ORDINANCE 95-30

TO AMEND THE BLOOMINGTON ZONING MAPS FROM RS3.5/PRO6 to PUD, AND APPROVE THE PRELIMINARY PLAN Re: 2031 S. Weimer Road (Cora Ann Sudbury, Petitioner)

Case #PUD-26-95
(RS/PUD/BL/PCD-26-95)

To: Rodney Young, Plan Commission Members
From: Kevin Komisarcik, Moira Wedekind
Subject: Sudbury Farm PUD
Date: June 21, 1995

Site Plan

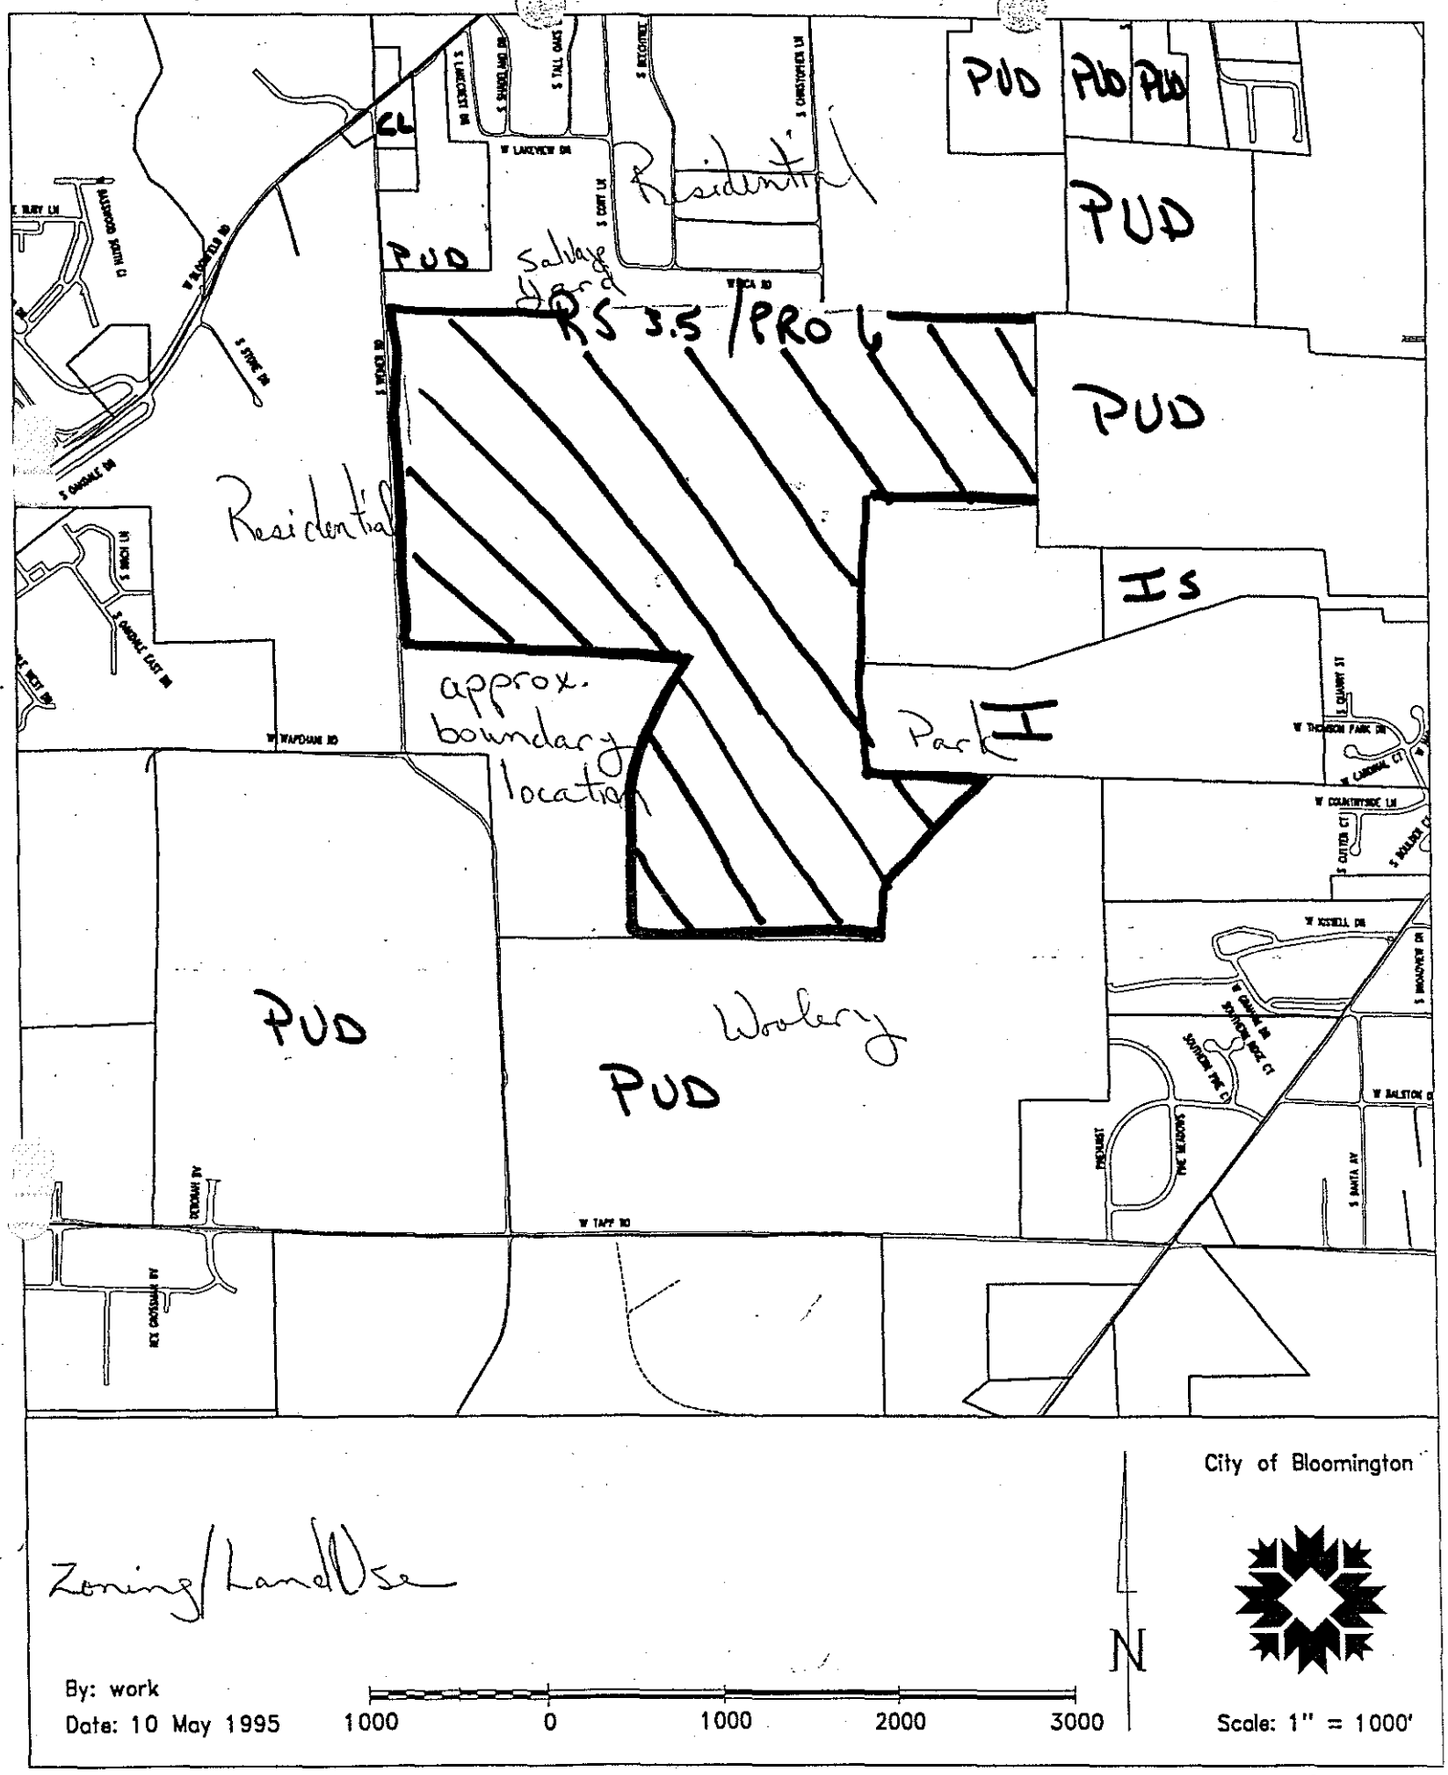
1. The original placement of the main arterial road is not well positioned given the karst features on this property. The road is placed such that it will impact a number of sinkholes on the property. As you know, the new city ordinance prohibits building within 25 feet of such features. We suggest two alternatives:

a. The road be moved towards the eastern boundary where it will be partially adjacent to Thompson Park, affording better access to its' western edge. This is the alternative route shown on the updated map.

b. The road be routed towards the western part of the development where it will be out of the forested area. This would follow the approximate location of the side street also shown on the map.

Either alternative would be an improvement over the current proposal by avoiding the sinkholes.

2. The proposed plan shows a band of higher density development partly in the forested area in the southern part of the site (parcel 5). We recommend that this portion of the development be moved to the non-forested area of the site (the western portions of parcels 5 & 6) and move more of the lower density development in parcel 6 into the woods. In other words the parcels would now align east - west rather than north - south. In this way more of the forest canopy will be saved.

Revised Adams alignment will relate better to sinkholes and grades. Generally, lower residential densities in tree areas will allow more preservation. Expect good detailing of specific preservation in final plans. Environmental Commission subcommittee comment has been considered by the Commission. The road has been revised but land uses remain as proposed.

ADAMS STREET SECTION

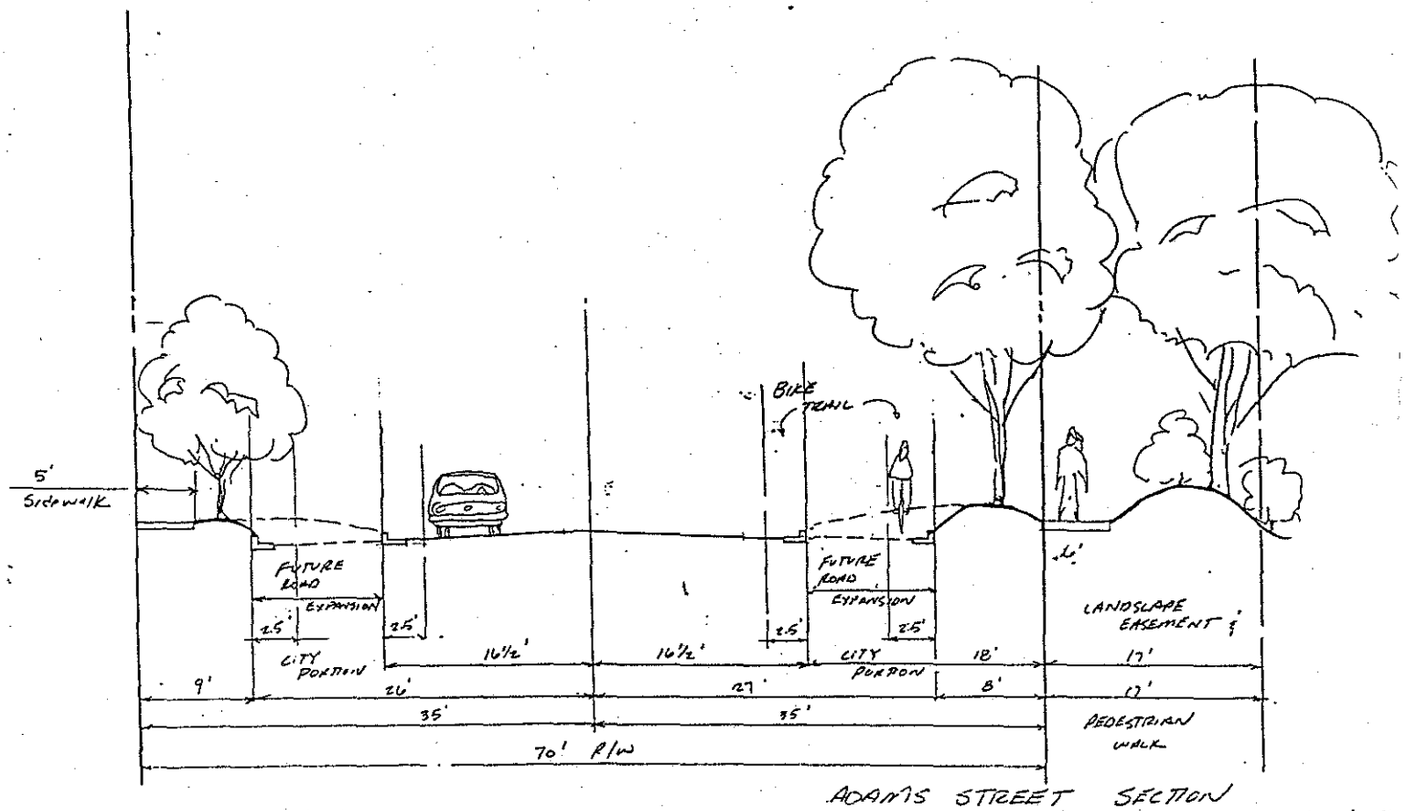
The departures from specific constraints are identified in the petitioner's statements, including the imposition of other constraints, particularly for the business area. In other respects, code standards will prevail. The mix of densities and uses is appropriate to the site. Small front and side setbacks will facilitate working with topo and tree features, and achievement of the proposed density. Adams St. geometry will conform to ASHTO standards to facilitate sinkhole avoidance.
